**Re: Toyota Temporary Parking Lot, Grading and Drainage Plan
Engineer's Stamp Date 4-13-15 (C18D083)**

**RE: Grading Plan
Toyota Temporary Lot
C18D083
Albuquerque, New Mexico**

**Re: Toyota Temporary Parking Lot, Grading and Drainage Plan
Engineer's Stamp Date 2-24-15 (C18D083)**

AMERICAN TOYOTA TEMPORARY CONSTRUCTION YARD	DRAWN BY: MCMU DATE: 2-25-15 PROJECT: 1501-1501-00-01
	GRADING AND DRAINAGE PLAN Rio Grande Engineering 1408 CENTRAL AVENUE SE ALBUQUERQUE, NM 87106 (505) 263-3888	SHEET # JOB # 21403

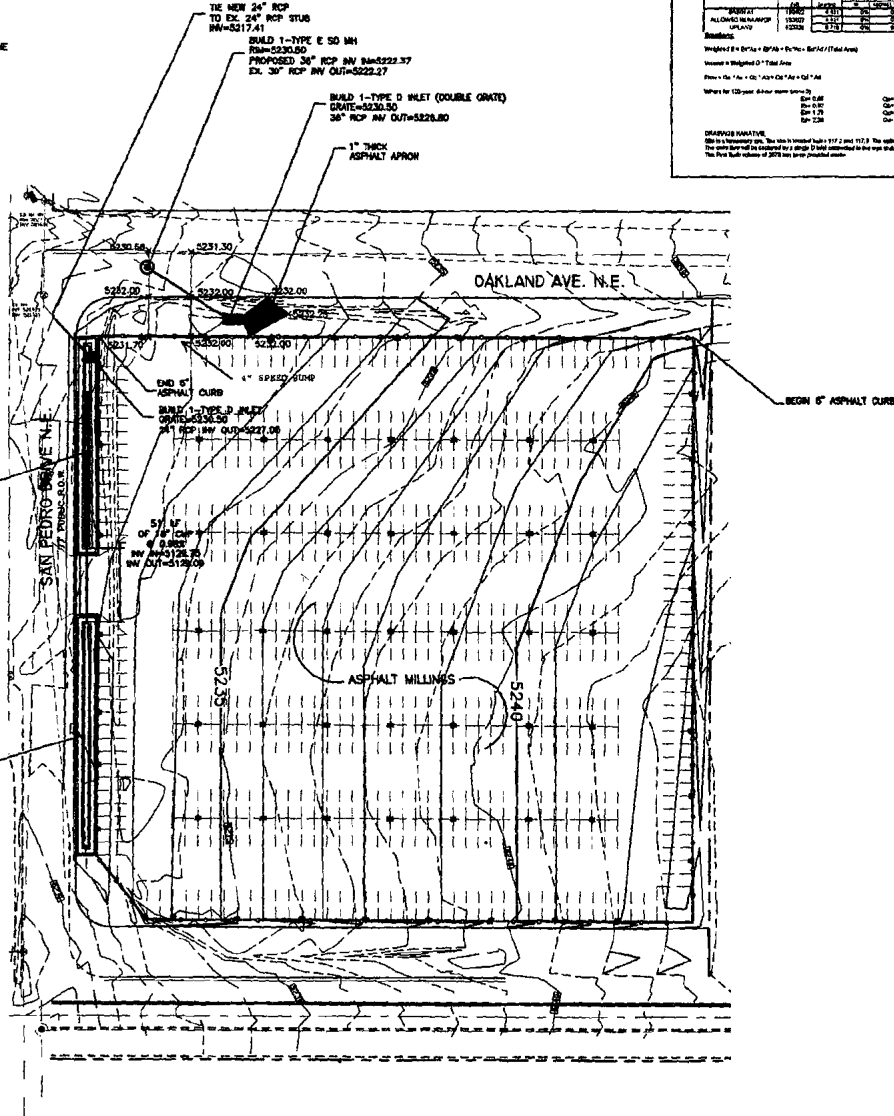
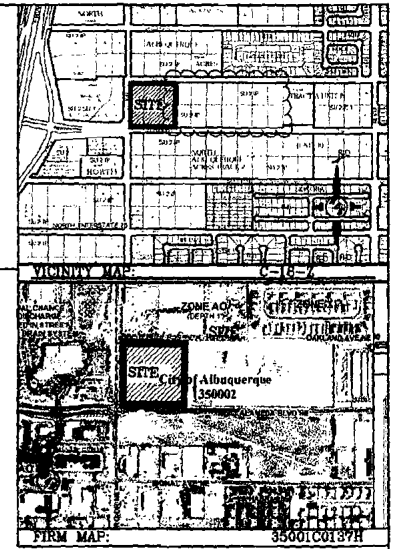
1. It appears an asphalt curb is needed to force the water into the first flush pond. In addition erosion protection is required where concentrated flows enter the ponds

2. Work within the right of way requires a work order

1. It appears a large portion of Onsite Basin A will drain to Oakland Ave ROW rather than to the northern onsite pond. Since the millings have already been laid, an asphalt curb could be constructed form the west edge of the millings east to the proposed 35 contour. Millings or similar should be laid where these concentrated flows will enter the pond to prevent erosion.
2. The work in the ROW will be built per the Work Order process, including the asphalt apron in Oakland Ave. Add a note to the existing build notes, that these times will be built per Work Order.

We have added the curb and called for rip rap to be placed at the location concentrated flows enter the ponds.

We have added this note to the plan set.
